**ADDENDUM THREE
NORTH ST ELMO DRAINAGE SYSTEM STUDY AND UPGRADE
CONTRACT NUMBER S-09-008-201
CITY OF CHATTANOOGA, TENNESSEE**

The following changes shall be made to the Contract Documents, Specifications, and Drawings:

FIGURE NO.
2

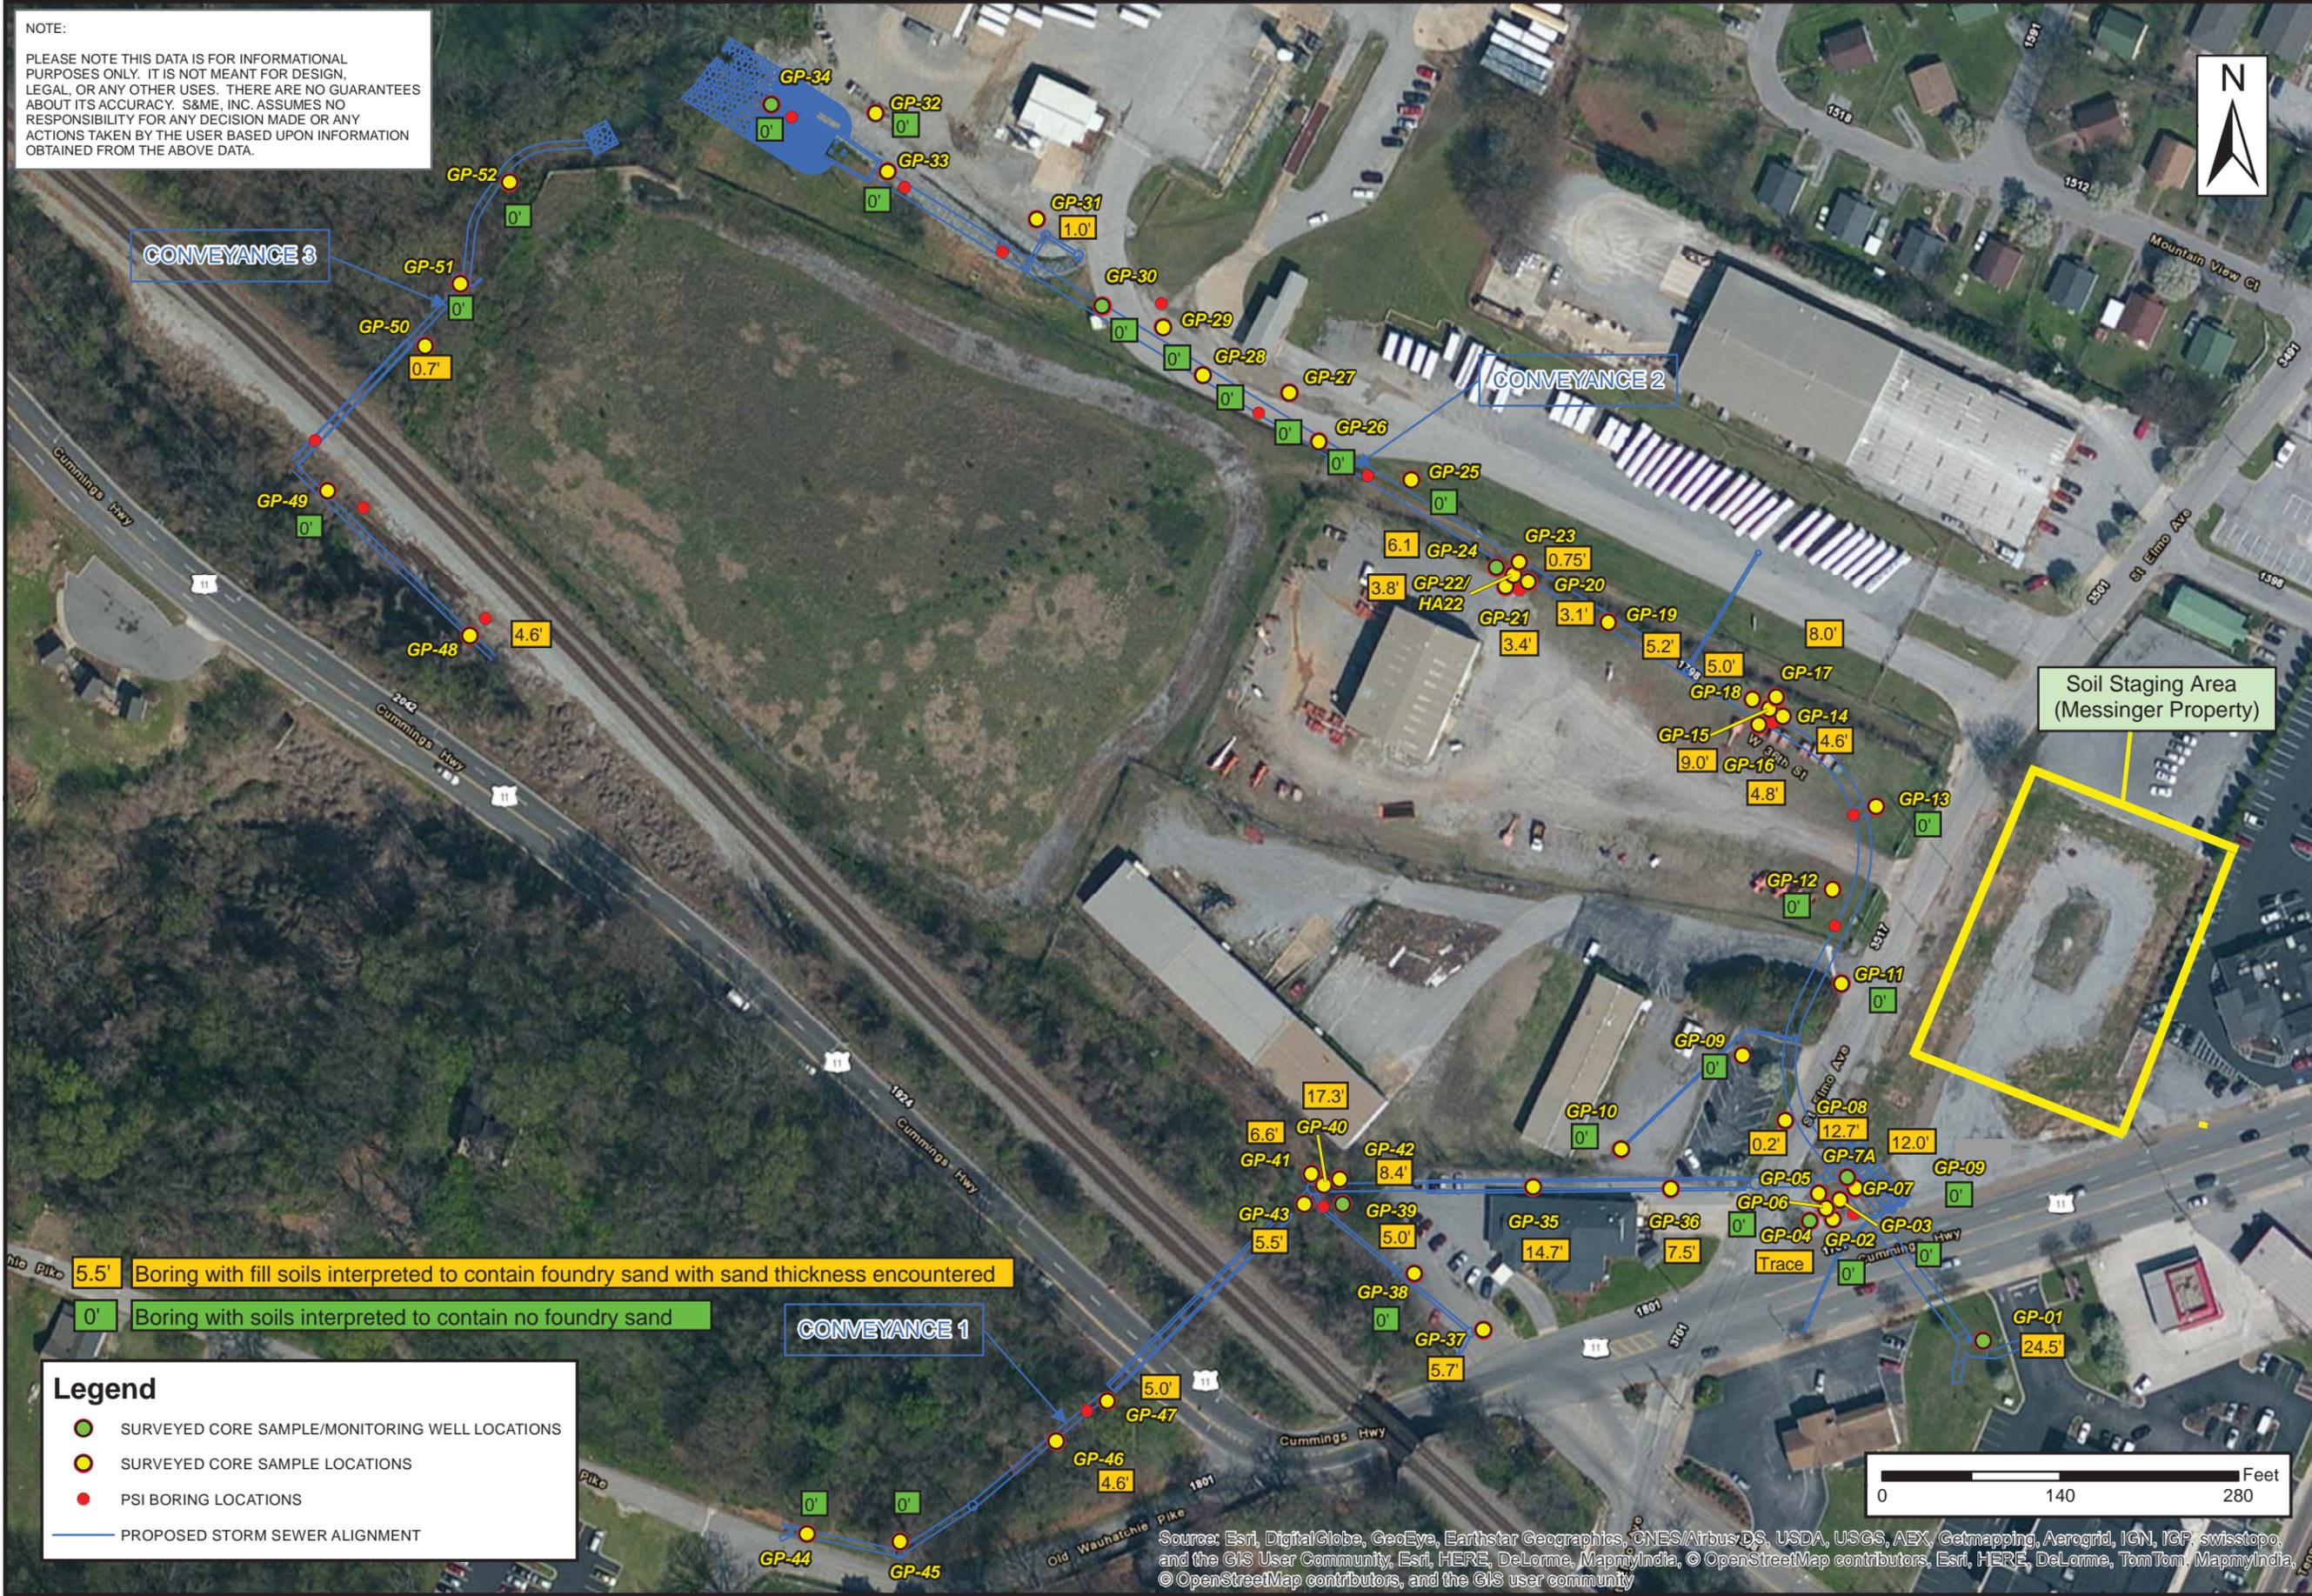
7. **Where can we stockpile material that we dig out from the ditch to be tested? Can we get a general idea of locations?** Figure No. 2 in Appendix F “Soil and Groundwater Management Plan” shows the available area for stockpiling soil. A revised Figure No. 2 is attached to this addendum.

1. Replace Contract Documents and Specifications page 00100-1 with 00100-1R1
2. Replace Contract Documents and Specifications page 00201-1 with 00201-1R1
3. Replace Contract Documents and Specifications, Appendix F "Soil and Groundwater Management Plan", Figure No. 2 with the attached Figure No. 2.

A-5

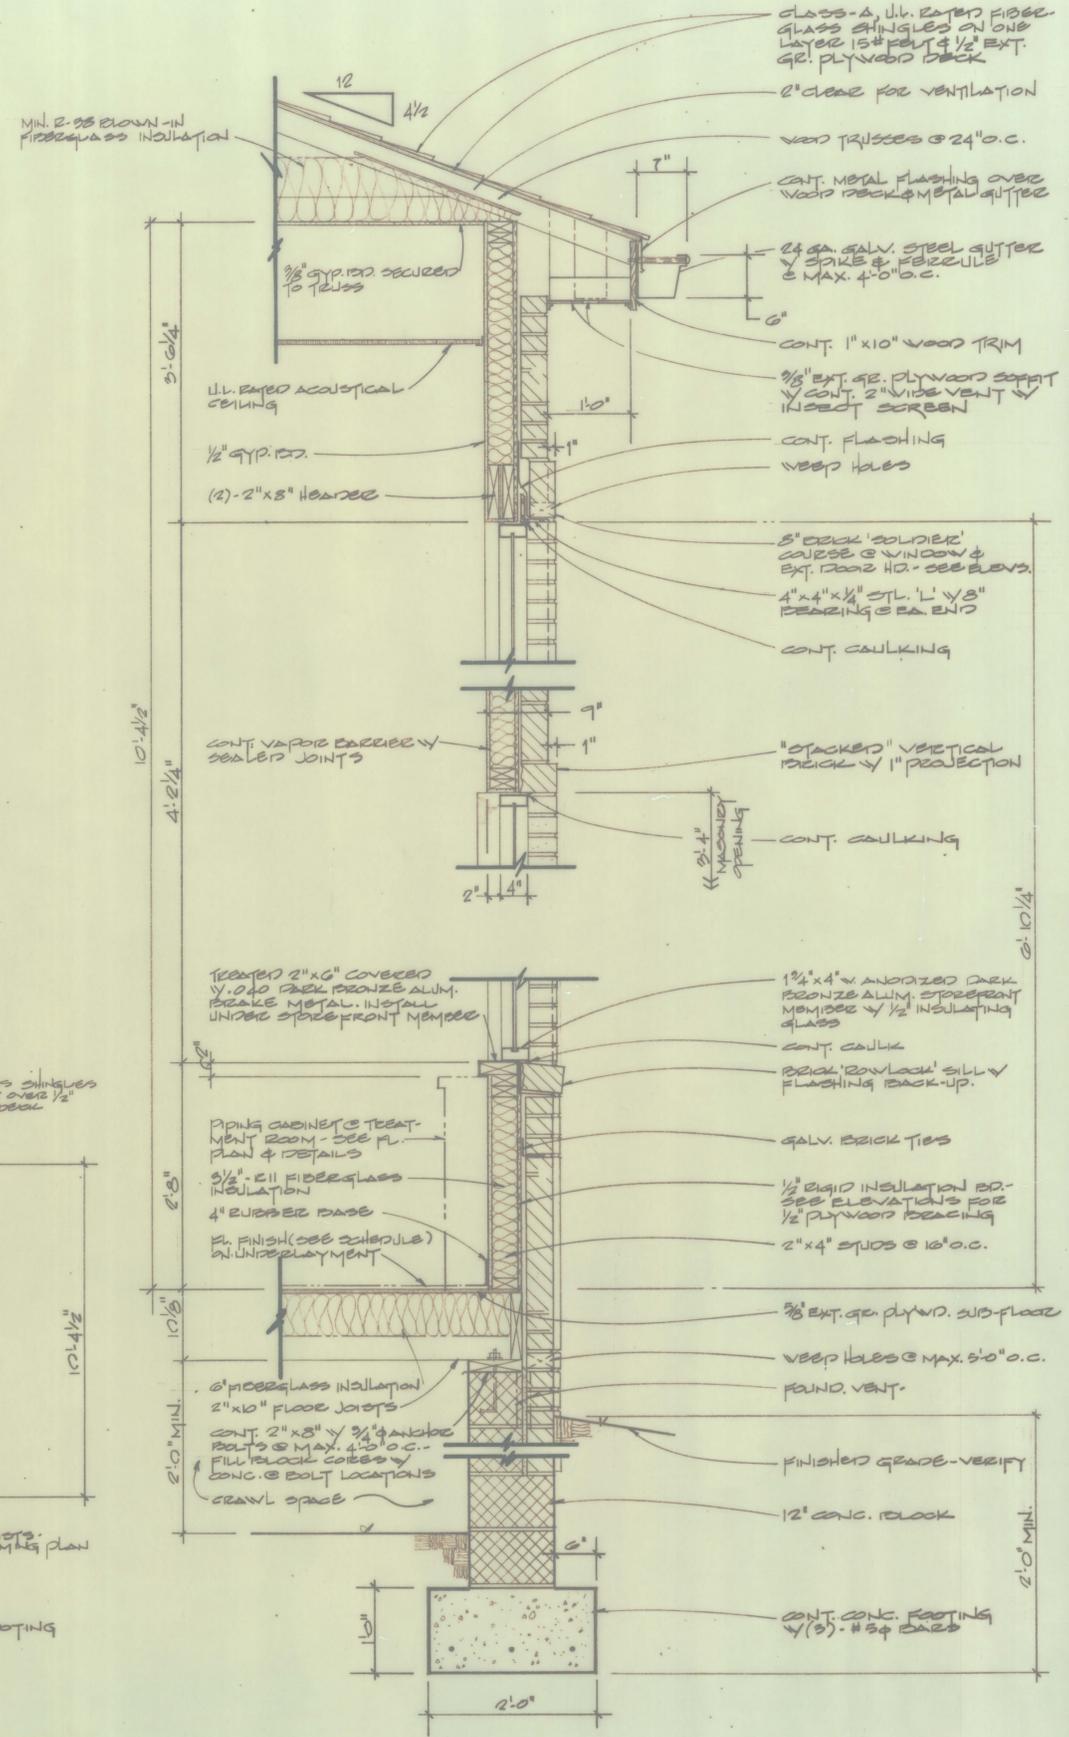
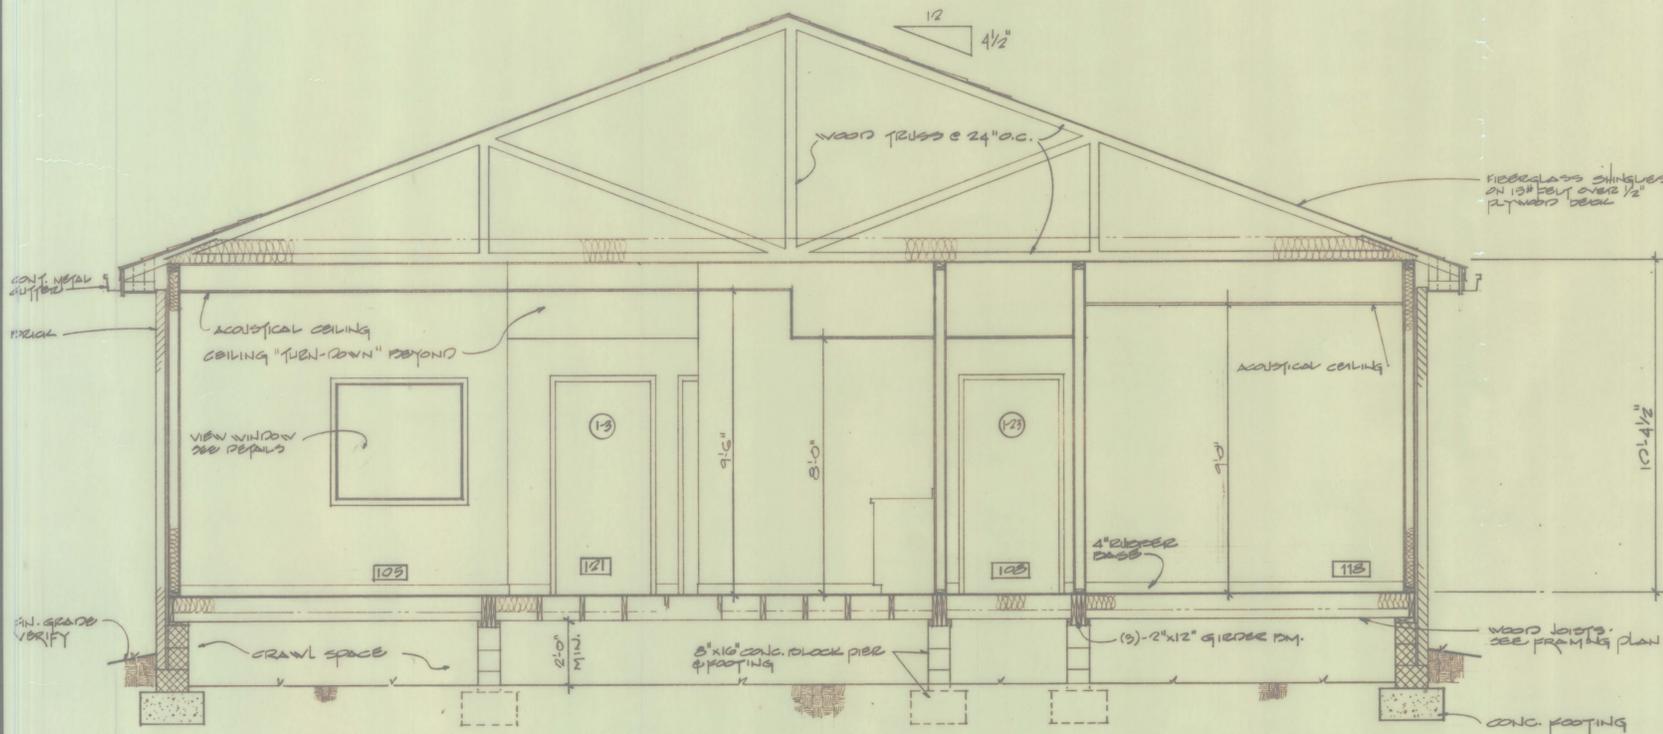
1. Since Addendum One was issued, new information has been acquired regarding the dialysis clinic foundation. As a revised response to question 14 in Addendum One, attached is a drawing depicting the foundation details for the dialysis clinic.
